TENNESSEE VALLEY AUTHORITY

Enclosed is a complete package containing proposed modifications to the draft Watts Bar Radiological Effluent Technical Specifications (RETS). Included with each proposed modification is a marked up page of the NRC draft specification along with a justification for each change. This package addresses the following questions that we received informally from the NRC's Watts Bar standard technical specification reviewer: A.4 (Additional Information Required to Complete Technical Specifications - Question #4), A.5, D.23 (Differences Between the Applicant's Proposal and the NRC Draft Technical Specifications - Question #23), D.29, D.30, D.31, D.32, D.71, D.73, and D.74.

ENCLOSURE
WATTS BAR NUCLEAR PLANT TECHNICAL SPECIFICATIONS
RELATED TO RADIOLOGICAL EFFLUENTS

WATTS NUCLEAR PLANT TECHNICAL SPECIFICATIONS
RETS PROPOSED CHANGES

Open Item #220
T.S. page 3/4 11-15

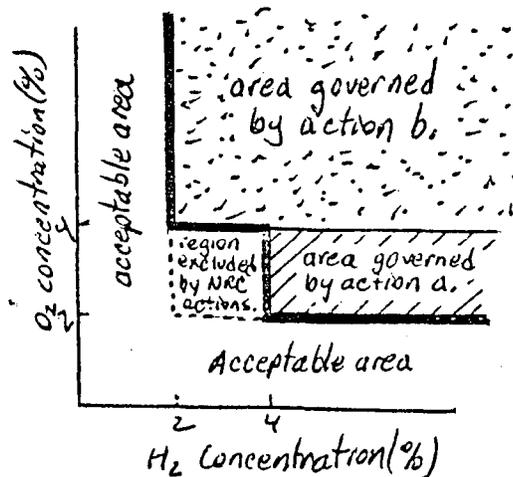
Explosive Gas Mixture Action Statements - Action statement 'a' requires that when the concentration of O_2 exceeds 2 percent by volume but is less than 4 percent by volume, we must reduce the O_2 concentration to the limits specified in the LCO (O_2 less than or equal to 2 percent when H_2 exceeds 4 percent). Our interpretation is that the O_2 limit can only be violated when the H_2 level exceeds 4 percent. Therefore, action 'a' only applies when H_2 exceeds 4 percent. This is how TVA interprets this requirement. The last phrase should be revised to read 'reduce the oxygen and/or hydrogen concentrations to the above limits within 48 hours.' We disagree with two portions of NRC's revision to action statement b. We think that the phrase 'and the hydrogen concentration greater than 2 percent by volume' should be reinserted. There is no explosive potential with H_2 less than 2 percent--NRC's revision is overly restrictive. We also think that the last phrase added by NRC should be revised to read 'and reduce the hydrogen and/or oxygen concentrations to the above limits within 48 hours. . .the limit.'

The basis for these requests can best be illustrated by the following figure.

- a. With the concentration of oxygen in a waste gas holdup tank greater than 2% by volume but less than or equal to 4% by volume, reduce the *hydrogen and/or* oxygen concentrations to the above limits within 48 hours.
- b. With the concentration of ^{Do not delete} oxygen in a waste gas holdup tank greater than 4% by volume ~~and the hydrogen concentration greater than 2% by volume~~, immediately suspend all additions of waste gases to the affected waste gas holdup tank and reduce the concentration of oxygen to less than or equal to ~~2%~~ ^{4%} by volume within one hour, ~~and 2% by volume~~ *and reduce the hydrogen and/or oxygen concentrations to the above limits*
- c. The provisions of Specifications 3.0.3 and 3.0.4 are not applicable.
